September 8, 2015

Re: City of Santa Monica Comments to the Southern California Metroplex Draft Environmental Assessment

Appendix 1
Proposed SMO Alternatives Shown in EA Exhibit 3-8

SMO Proposed RWY 21 SID PEVEE

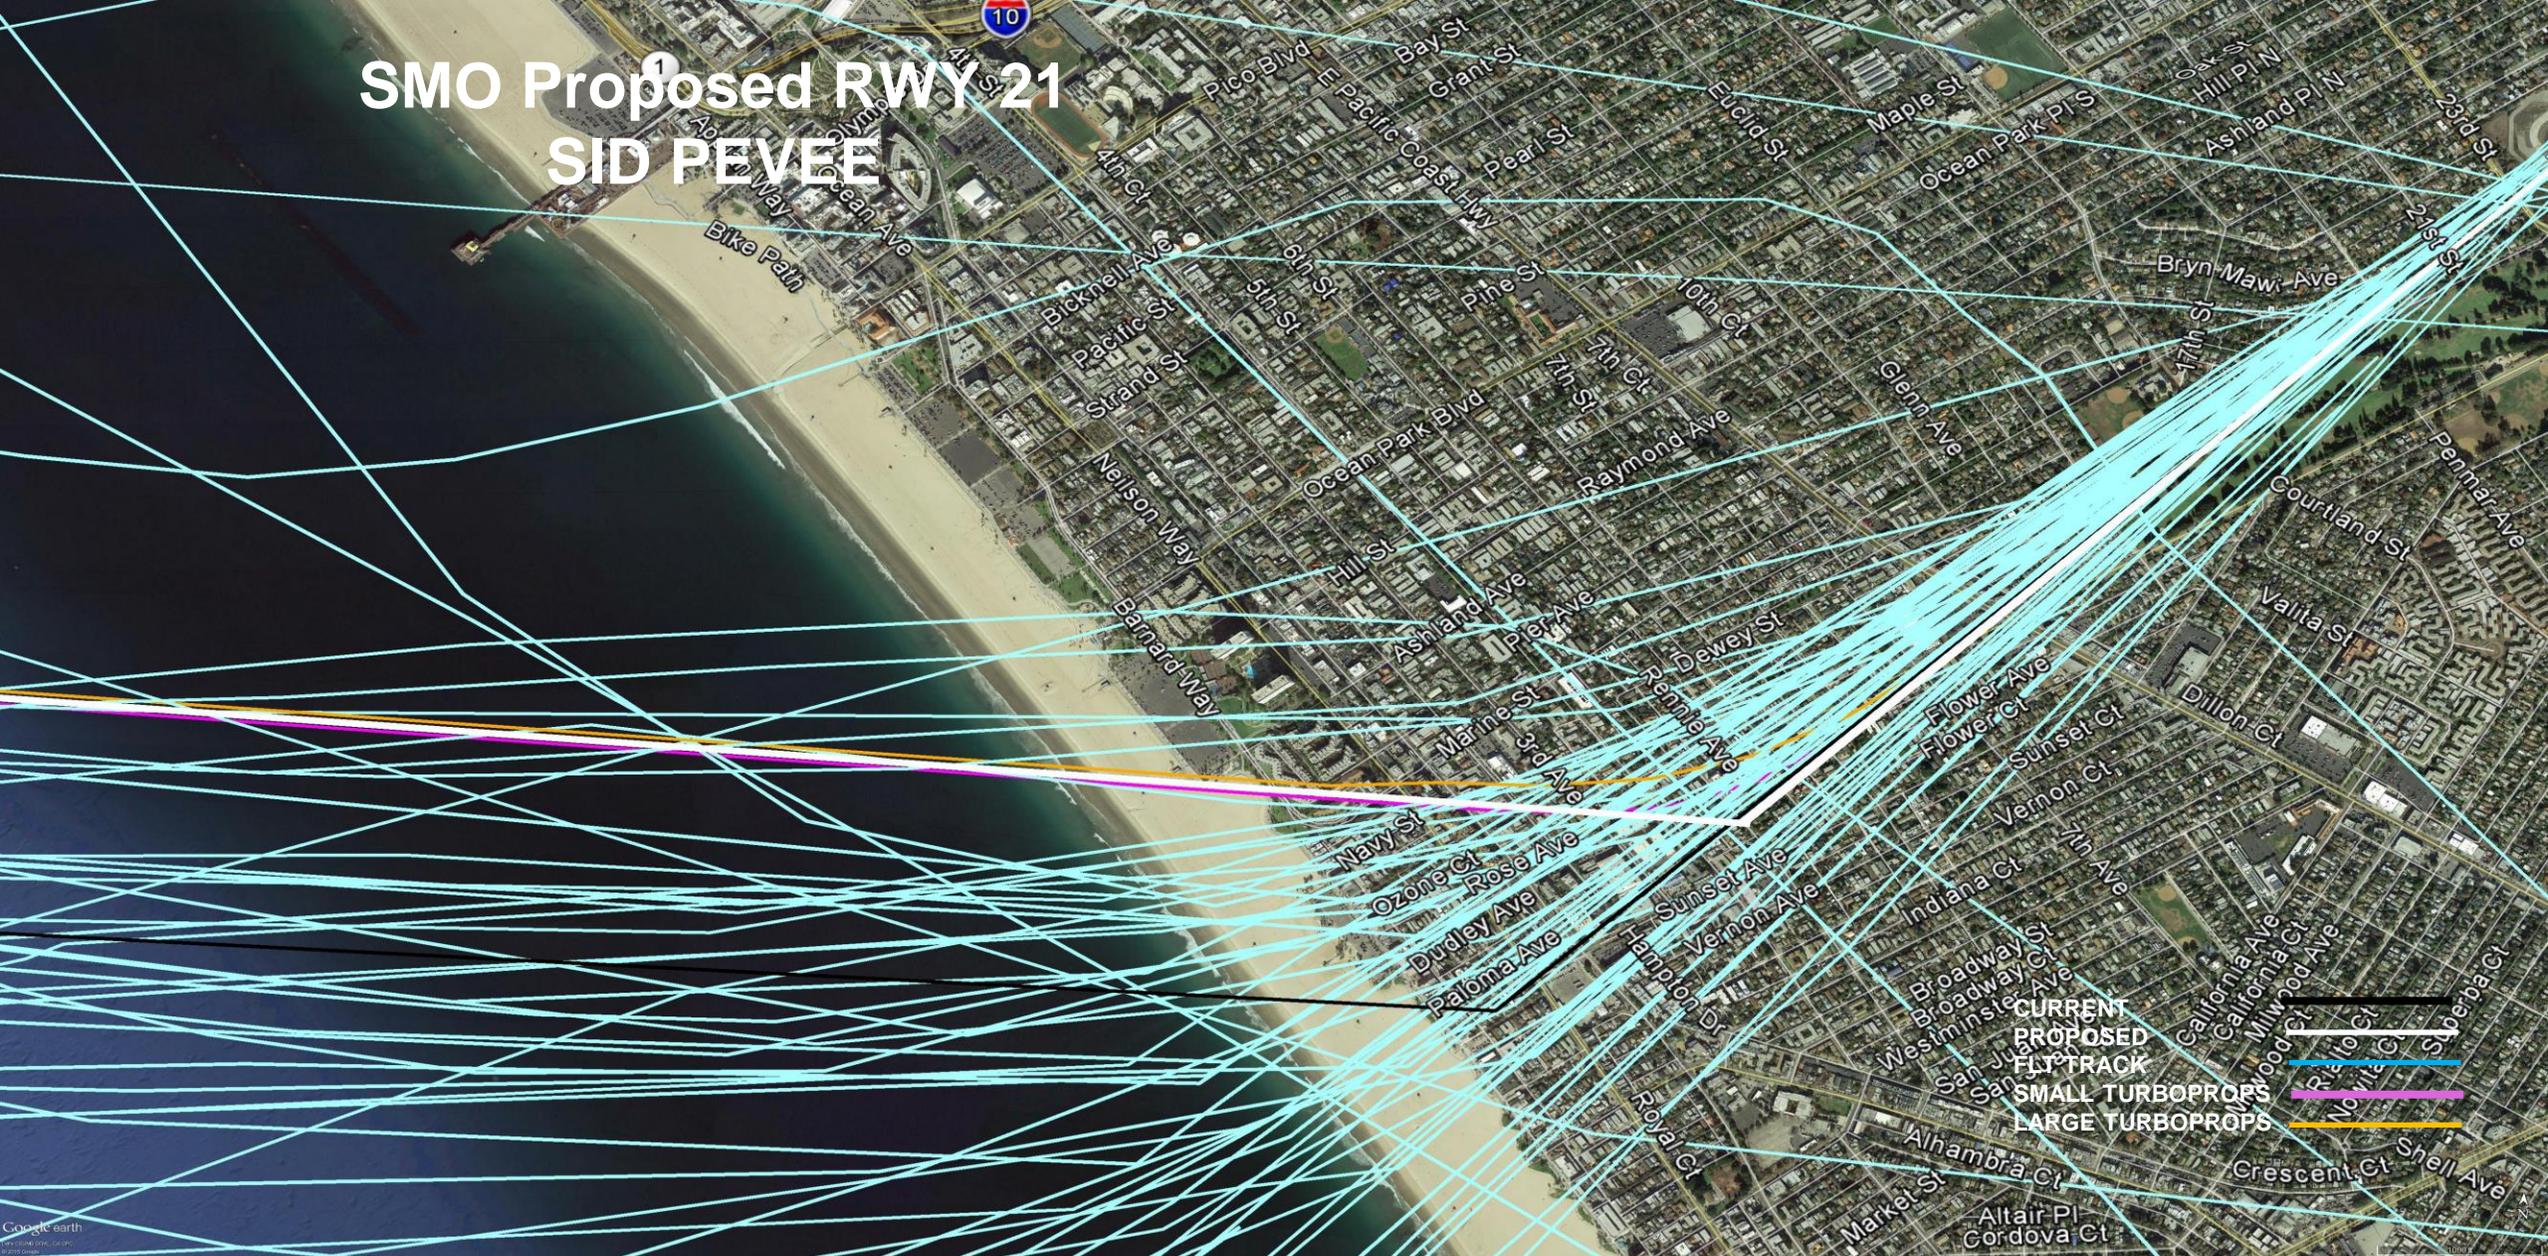
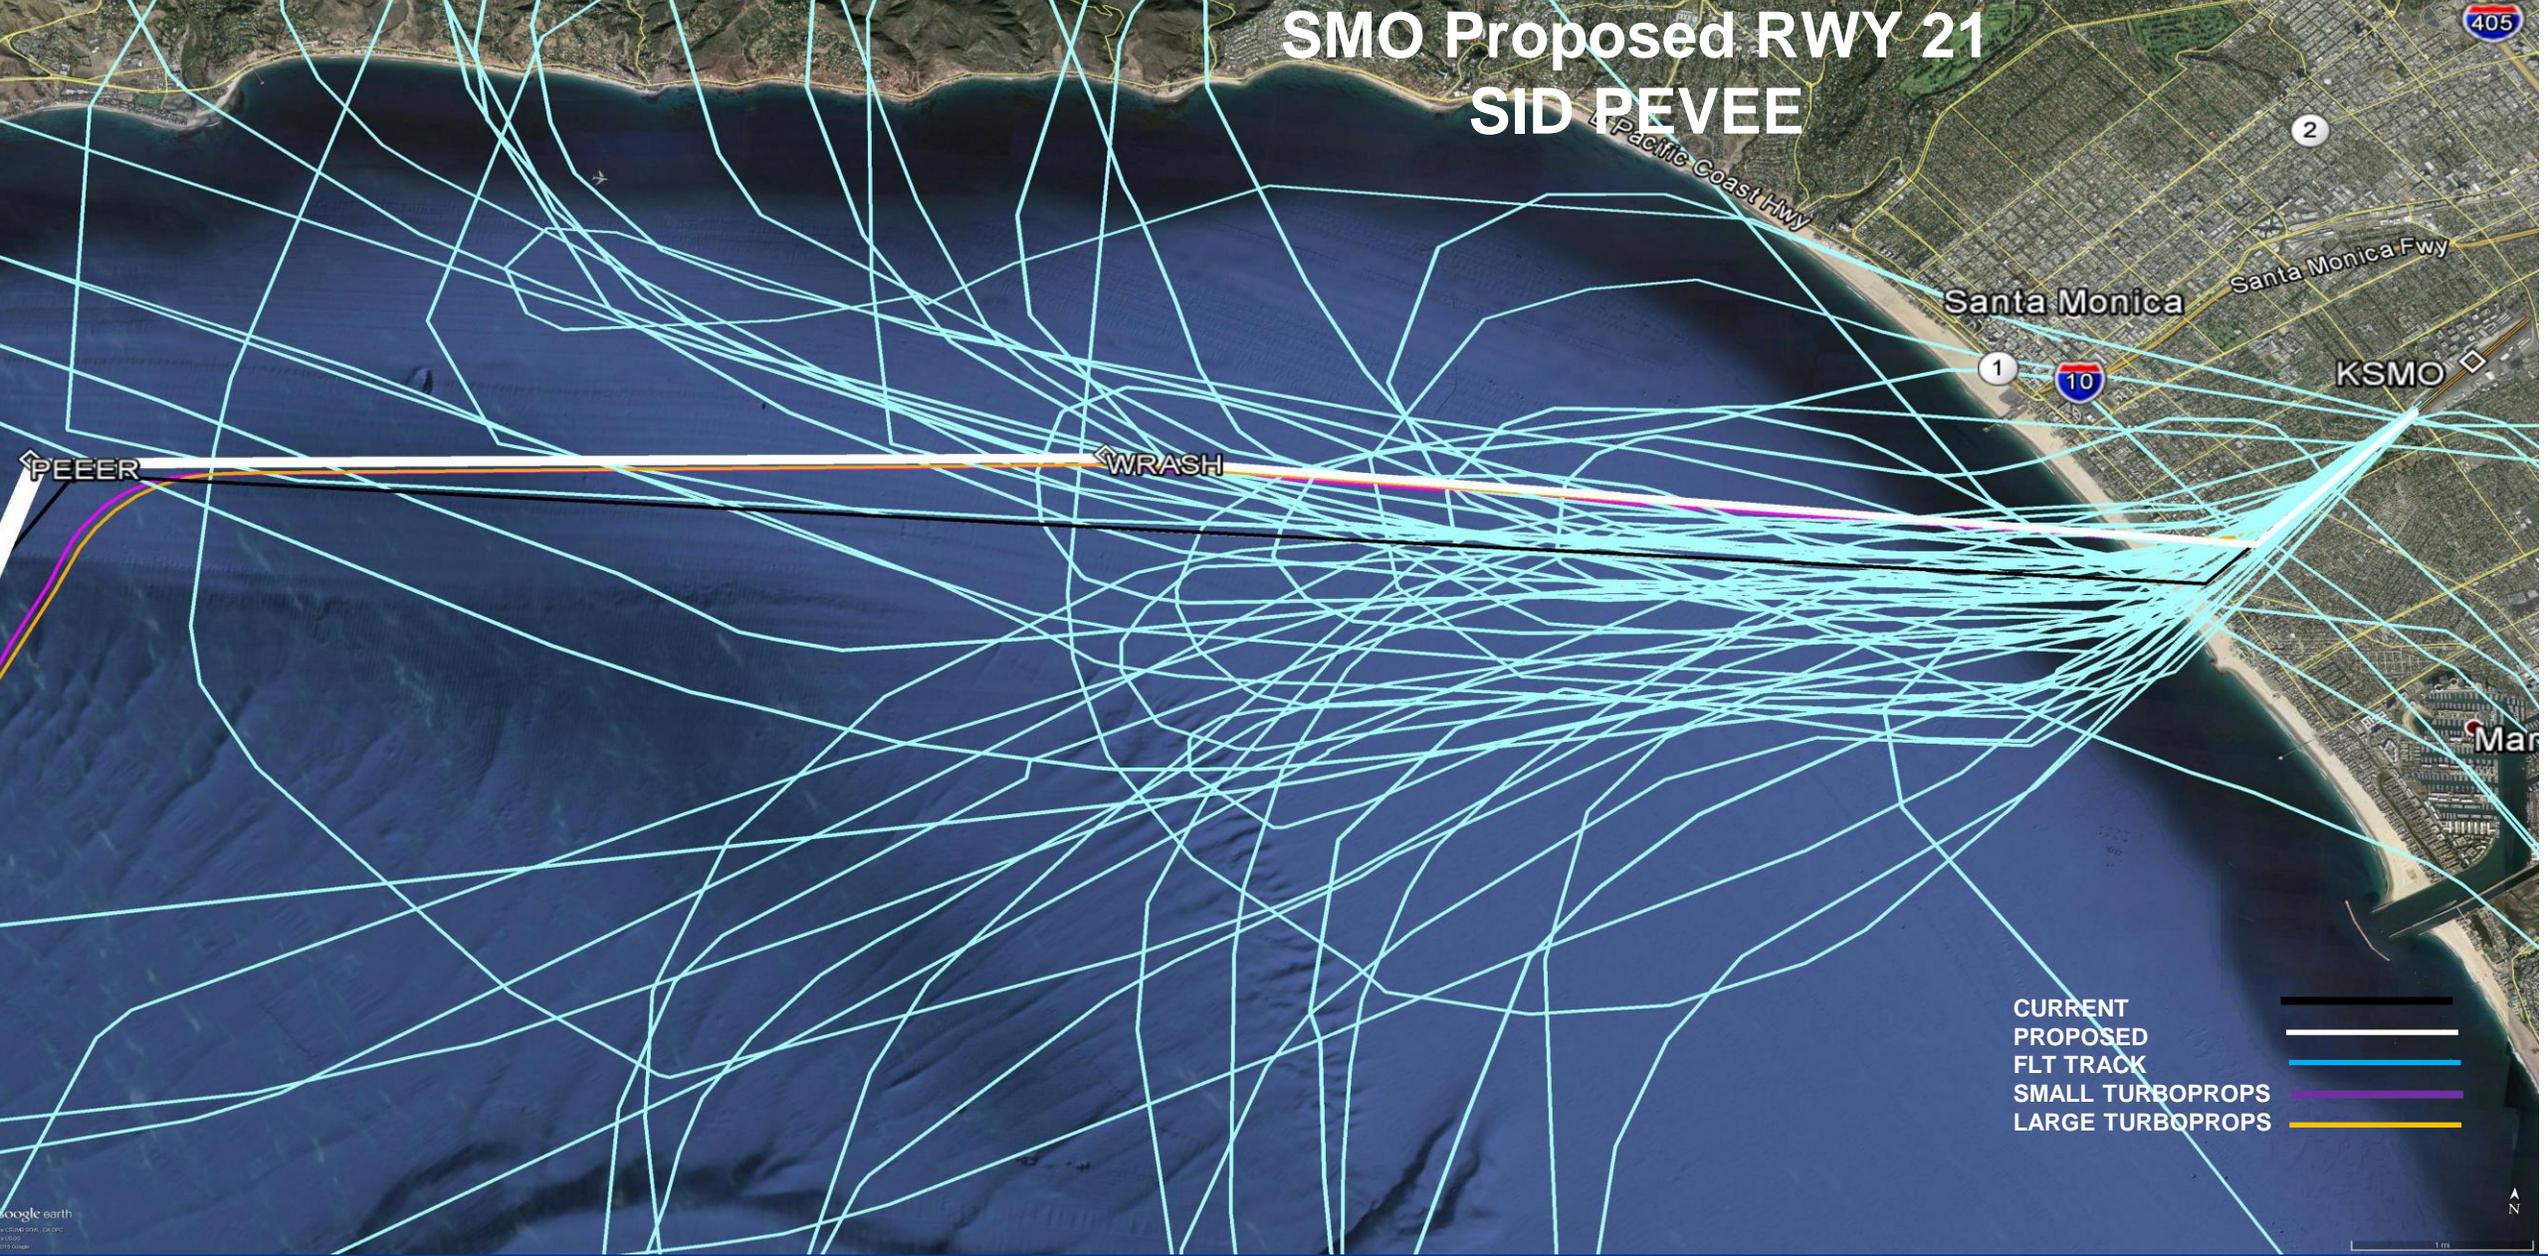
Although the City supports the goal of saving fuel and reducing idling time while aircraft await clearance, which would be beneficial to the environment and to aviation efficiency, a major concern to the City of Santa Monica is the location of the right turn for SMO departures from Runway 21 to the west. The current procedure requires that aircraft fly straight off the runway heading to the west and begin turning at the shoreline. The proposed procedure suggests a turn half way between the runway end and the shoreline. The new early turn will repurpose aircraft north from the current departure path, thereby significantly affecting residences that currently have a small number of overflights to experience the majority of the instrument departures out of SMO. The FAA presentation is misleading in that the legend identifies the flight tracks as only for small turboprops and large turboprops, but it is silent regarding piston driven and turbine aircraft that represent the largest portion of the SMO aircraft fleet. The FAA has implied, but has not stated in this EA that these procedures apply to all aircraft.

As mentioned above, this EA relies on the DNL metric threshold of an increase of 1.5 dB within the 65 DNL contour as the definition of a significant impact. This proposed early turn is well outside the 65 DNL contour so no matter what the noise increase, the finding is of no significance. What the EA importantly does not address is what the community response will be, and the information provided in the EA is insufficient to make that determination. The EA relies solely on the DNL 1.5 dB change threshold even though the FAA knows that even in places where this threshold has been met the community response has been highly negative.

The case clearly shows that FAA may, and if fact has, considered noise levels as low as 45 DNL in considering a noise abatement flight routes and successfully defended that policy in face of industry challenges. The City of Santa Monica would expect no less in the consideration of the right turn that is proposed before the coastline to a point after the coastline.
